Commission for
Communications Regulation

Plum Consulting's responses to the comments received from interested parties in response to ComReg consultation Document 15/70 on 3.6 GHz spectrum award

Reference: ComReg 15/140c

Date: 22 December 2015

Figure A-2: Frame alignment between adjacent PMP450 and LTE networks

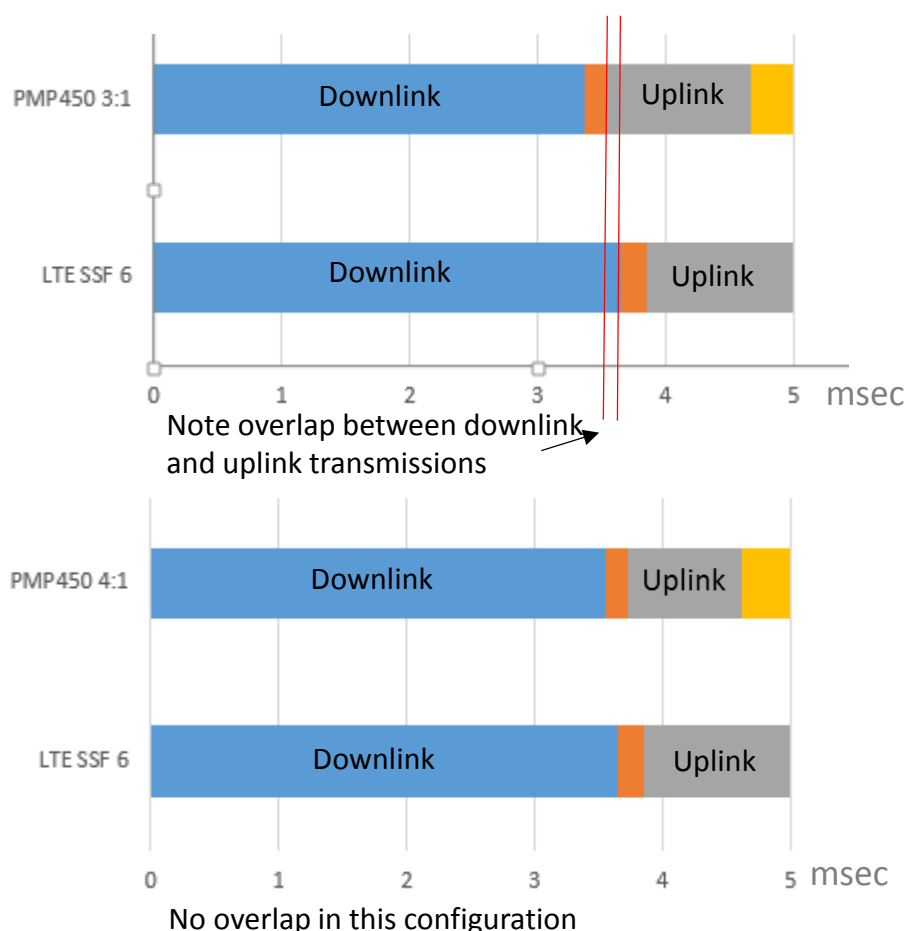
Note that due to differences in the frame structure, compatibility may in some cases be better achieved by using a different downlink / uplink ratio in the PMP 450 system. For example, a typical PMP 450 configuration based on a 10 mile cell radius and 3:1 downlink / uplink ratio yields a downlink finish time of 3.37 msec and an uplink start time of 3.54 msec, according to Cambium’s collocation tool. The latter is less than the downlink finish time for TD-LTE if SSF options 1 or 6 are deployed, meaning interference would arise. However if the downlink / uplink ratio is set to 4:1 the respective values become 3.56 msec and 3.73 msec, which means the PMP 450 uplink start time is after the end of the LTE downlink transmission and interference is avoided. This is illustrated in the figure below. Note that although differences in the specific frame structure can be accommodated (so long as the transmit and receive periods do not overlap), it is important the frames in both systems are aligned in terms of the start of the downlink transmission, to avoid the risk of this overlapping with the adjacent system’s uplink.

The latest implementations of the Cambium PMP 450 wireless access product (Release 13.2 onwards) provide the option of a 5 msec frame length that is compatible with WiMAX (802.16e) and, by implication, also compatible with TD-LTE systems using frame configuration option 2. To ensure effective synchronisation between networks it will be necessary to know the precise frame configuration for the TD-LTE network, in particular the special sub-frame (SSF) option that is deployed and to set the transmit / receive timings in the PMP 450 system so that these do not conflict with the timings for the TD-LTE network. This can be done by setting appropriate parameters in the PMP 450 frame calculation tool. Note that this may result in a small reduction in the maximum throughput of the PMP 450 system (due to reduction in the uplink and/or downlink durations), but this would be offset by the benefit arising from deployment of the more permissive spectrum mask. Note also that the frames of the adjacent systems must be aligned in terms of the start of the downlink transmit period, to avoid the risk of transmit / receive overlap.
